CONTRACT CHANGE ORDER NO. _____
SHEET ____ OF ____

MARK	DATE	DESCRIPTIONS	BY	CH'D	CCO#
2	09/15/10	TRAVELER RAIL TOLERANCES	MN	TH	168
1	05/18/09	TRAVELER RAIL MODIFICATIONS	TH	RM	24S0
0	07/20/07	RAIL CHANGE AND MISCELLANEOUS DETAILS	TH	RM	24

SAN FRANCISCO OAKLAND BAY BRIDGE
EAST SPAN SEISMIC SAFETY PROJECT
SELF-ANCHORED SUSPENSION BRIDGE
(SUPERSTRUCTURE & TOWER)

SKYWAY TRAVELER RAIL REPLACEMENT DETAILS NO.5

MAXIMUM ALLOWABLE FLANGE DEFORMATIONS

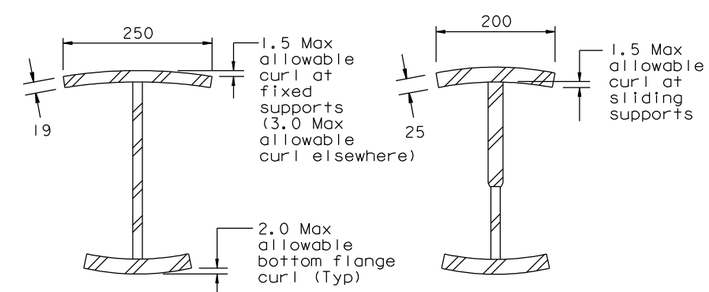
MARK	DATE	DESCRIPTIONS	BY	CH'D	CCO#
4	09/15/10	TRAVELER RAIL TOLERANCES	MN	GB	168
3	06/05/09	TRAVELER RAIL MODIFICATIONS	MN	GB	2450
2	07/20/07	RAIL CHANGE & MISCELLANEOUS DETAILS	GB	NV	24
1	08/04/06	TRAVELER RAILS	GB	NV	24

3. The Nominal 16 mm gap between rail sections is to allow for slippage movement between rail and box in major seismic event.
4. Rail gaps to be set only after all dead load is in place on the structure. Tolerances across gaps to be per "Traveler Rail Details No. 15" sheet.

SECTION F-F (Tolerances at rail sliding joints)

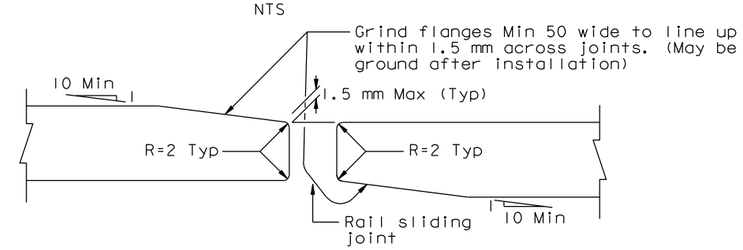
MARK	DATE	DESCRIPTIONS	BY	CH'D	CCO#
4	09/15/10	TRAVELER RAIL TOLERANCES	GB	MN	168
3	03/05/10	TRAVELER RAIL MODIFICATIONS	GB	MN	24S0
2	05/18/09	TRAVELER RAIL MODIFICATIONS	GB	MN	24S0
1	07/20/07	RAIL CHANGE AND MISCELLANEOUS DETAILS	GB	NV	24
0	08/04/06	TRAVELER RAILS	GB	NV	24

1. Adjust within the welds to the Tee section in order to achieve the required tolerances at the rail joints. Match mark for installation if necessary to achieve the tolerances shown after installation.
